19L ABWR Shutdown Risk Evaluation

The information in this appendix of the reference ABWR DCD, including all subsections, tables, and figures, is incorporated by reference with the following departures.

Figure 19L-3 Potential Path for Draining RPV Through Residual Heat Removal System (Pump On)

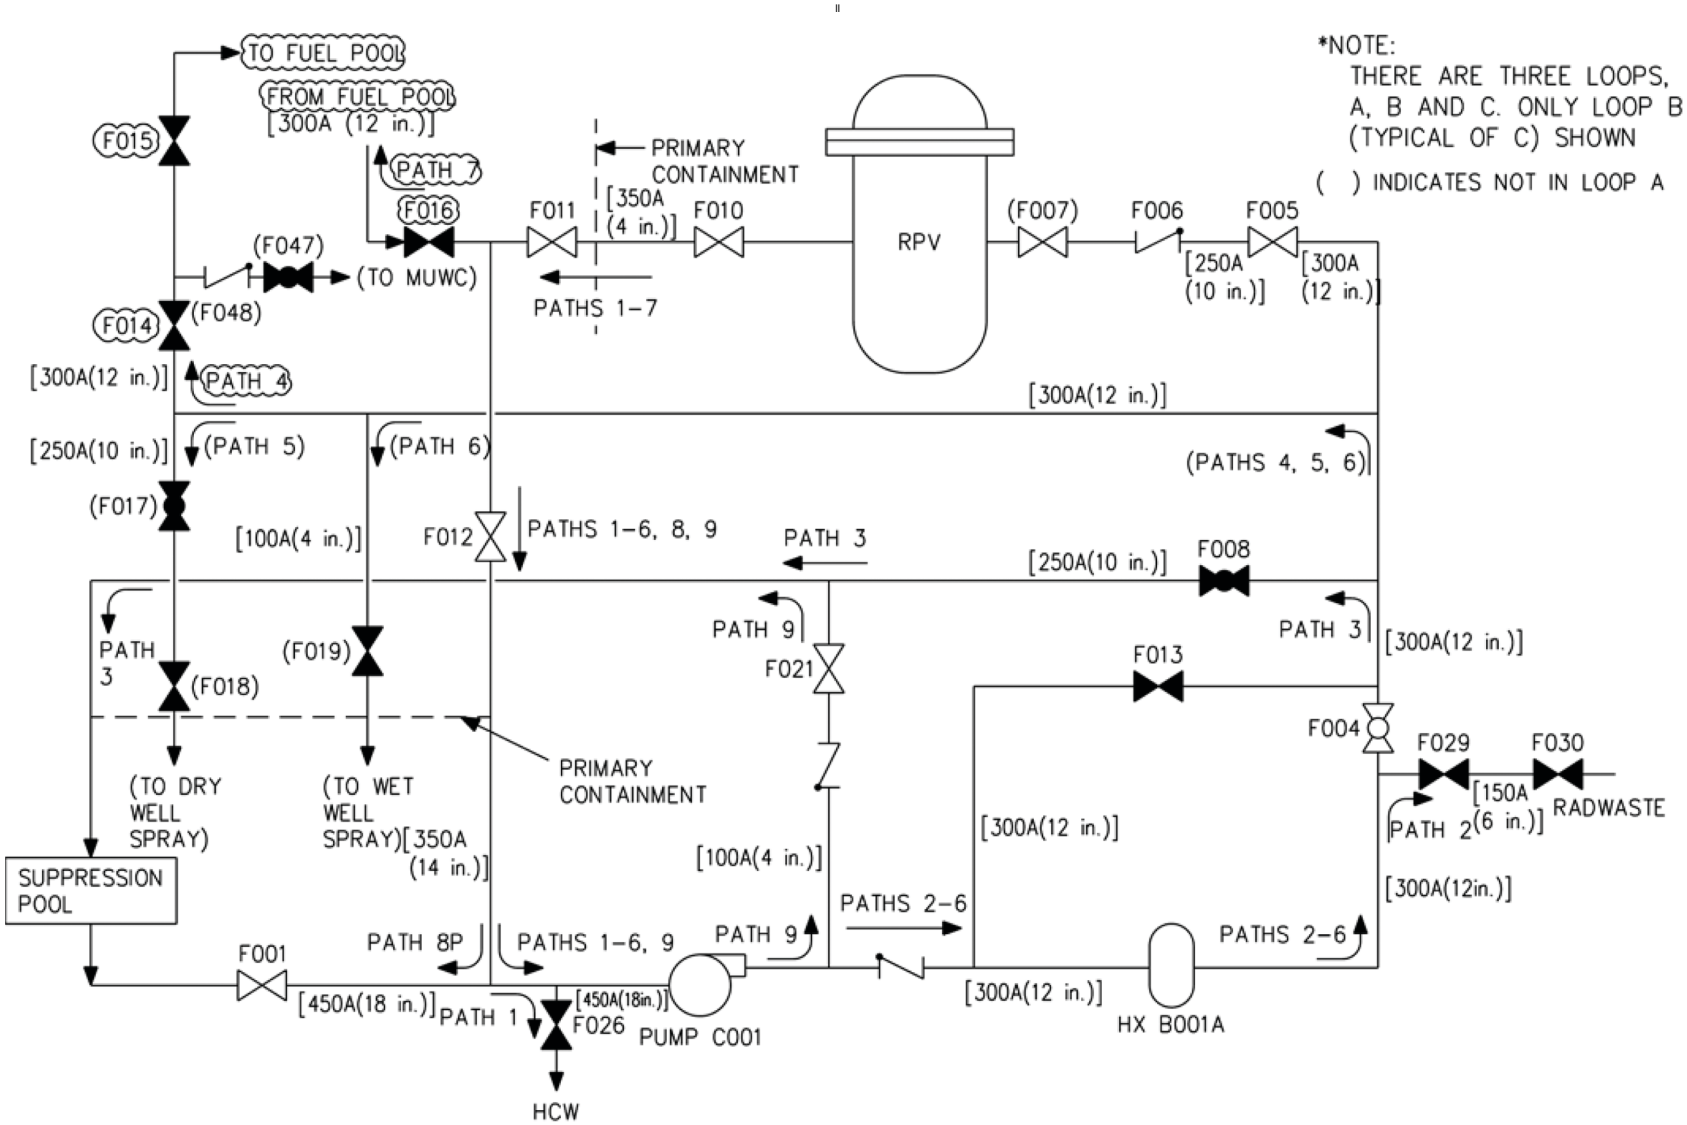
STD DEP T1 2.4-1 (Figure 19L-3)

STD DEP T1 2.4-1

The ABWR residual heat removal (RHR) system is a closed system consisting of three independent pump loops (A, B, and C-where B and C are similar) which inject water into the vessel and/or remove heat from the reactor core or containment. Loop A differs from B and C in that its return line goes to the RPV through the feedwater line whereas loop B & C return lines go directly to the RPV. In addition, loop A does not have connections to the drywell or wetwell sprays. ~~or a return to the fuel pool cooling system.~~ However, for purposes of this analysis, the differences are minor and the three loops can be considered identical. The RHR system has many modes of operation, each mode making use of common RHR system components. These components are actuated by the operator; hence, the operation is subject to operator error which could potentially lead to drainage of the RPV. Potential paths for draining the RPV through the RHR system during operating Modes 4 and 5 are discussed below, summarized in Table 19L-8 and depicted in Figure 19L-3. Of the various modes of RHR operation it was judged that the potential for RPV draining was the greatest during the shutdown cooling mode. Therefore, the potential RPV draining paths start with the RHR in the shutdown cooling mode of operation. As will be shown by the following consideration and analysis, the probability of draining the RPV through the RHR system is negligibly low. Even if all the preventive and mitigative features fail, RPV draining will stop when the RHR shutdown cooling nozzle is uncovered at which point there is still 1.6 meters of water over the top of the active fuel.
